SERVICE BULLETIN

Replacement of circlip (carburetor) for ROTAX® Engine Type 912 and 914 (Series)

ATA System: 73-00-00 Fuel system

MANDATORY

Fig. 5

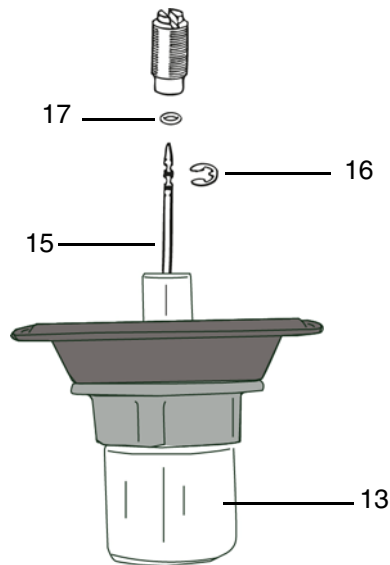
Step	Procedure
6	Remove jet needle (15) with circlip and O-ring from piston assy. (13).
7	Remove original O-ring (17) and circlip (16) from the jet needle (15) and discard. NOTE: Take note of the circlip's original needle position.

Fig. 6

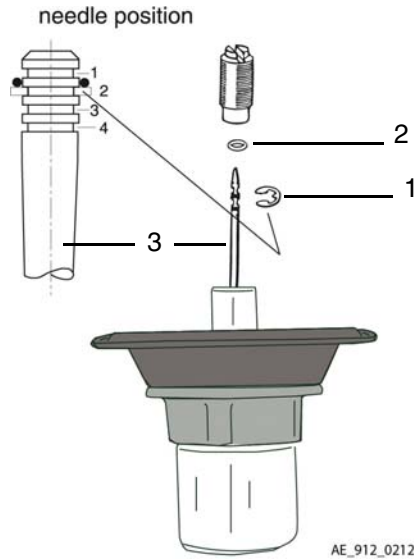
Step	Procedure
1	Place a new circlip part no. 945786 (1) into the same needle position. Place a new O-ring 2.5x1 part no. 950430 (2) over the jet needle (3).
